TR-5184-1

**INDEPENDENT COMPARATIVE
ASSESSMENT OF
HLW REPOSITORY SITES**

20 March 1985

UTILITY NUCLEAR WASTE MANAGEMENT GROUP

Figure 4.1-1. Comparison of DOE and TASC Results
Yucca Mountain, Hanford, and Deaf Smith

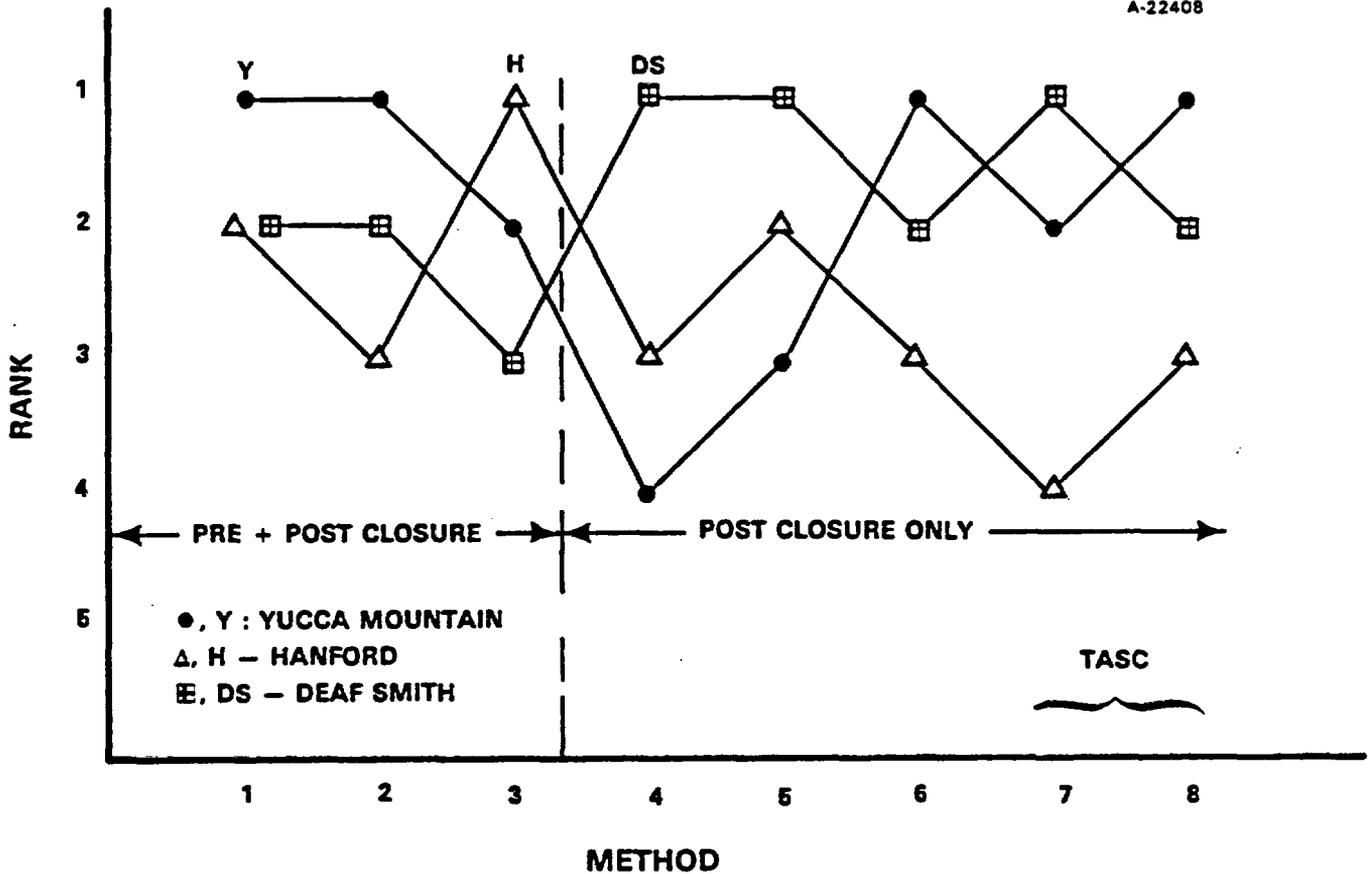
TASC's ranking results are compared to DOE results in Figs. 4.1-1 and 4.1-2. Figure 4.1-1 shows results for the Yucca Mountain, Hanford, and Deaf Smith sites; Fig. 4.1-2 shows results for the Richton and Davis Canyon sites. This separation of results avoids excessive clutter on one figure and puts all results for DOE's three top-ranked sites (Yucca Mountain, Hanford, and Deaf Smith) together.

The results shown in Figs. 4.1-1 and 4.1-2 can be interpreted to show that:

- DOE and TASC ranking results relative to the postclosure guidelines both show that consideration of the postclosure guidelines alone does not clearly distinguish the comparative rankings of the five sites
- Consideration of the preclosure guidelines in addition to the postclosure guidelines does distinguish Hanford, Yucca Mountain, and Deaf Smith as the top-ranked sites for all three comparative ranking methods used by DOE.
